Exelon Generation Company, LLC
Quad Cities Nuclear Power Station
22710 206th Avenue North
Cordova, IL 61242-9740

Quad Cities Nuclear Power Station, Unit 1
Facility Operating License No. DPR-29
NRC Docket No. 50-254

Subject: Change of Commitment to Inspect and/or Weld Overlay Repair Welds
02BS-F4, 02AS-S4 and 02AD-F12.

Figure 1

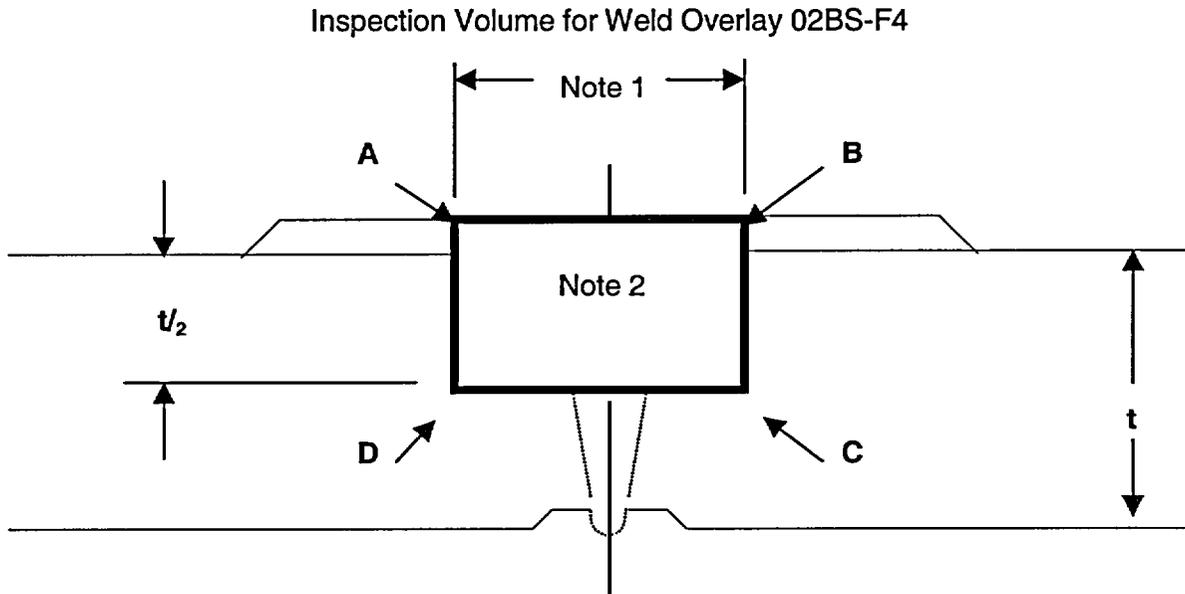
Weld 02BS-F4, with its unique design, was examined initially during Q1R16, following the GL 88-01 guidelines. The upcoming examination during Q1R17 will be the same as a full structural overlay as addressed in GL 88-01/BWRVIP-75, with the exception of the outer 25% through-wall of the original pipe wall thickness of base metal.

This component will be examined ultrasonically with manual PDI techniques through interrogation of the overlay weldment, the interface between the weldment and base metal and the outer 50% of the original pipe wall thickness of base metal for the width of the original underlying butt-weld and one-half inch of base metal on each side, as depicted in Figure 1.

EPRI/PDI has reviewed the applicable PDI procedure and basis for its qualification and determined that this procedure can effectively interrogate the 02BS-F4 weld overlay material and at least the outer 50% of the original base metal (i.e., a total of 0.85 in. of examination volume depth, including the weld overlay thickness of 0.25 in.) since the PDI procedure was originally qualified for a full structural weld overlay for a 1.42" maximum depth of the examination volume from the OD surface, which includes a typical 0.45" thick weld overlay material and the outer 25% of the typical 28" diameter original pipe wall (see Attachment 2). Therefore, we have concluded that the PDI qualified UT procedure can reliably detect flaws in the weld overlay and outer 50% of the base metal. Following the examination in Q1R17, a fracture mechanics evaluation will be performed and provided to NRC for review and approval prior to Unit restart.

Note 1: The width of the required inspection volume shall include the original pipe weld crown plus a minimum 0.50" from each weld toe.

2: The Inservice Examination Volume is bounded by points A, B, C, and D.
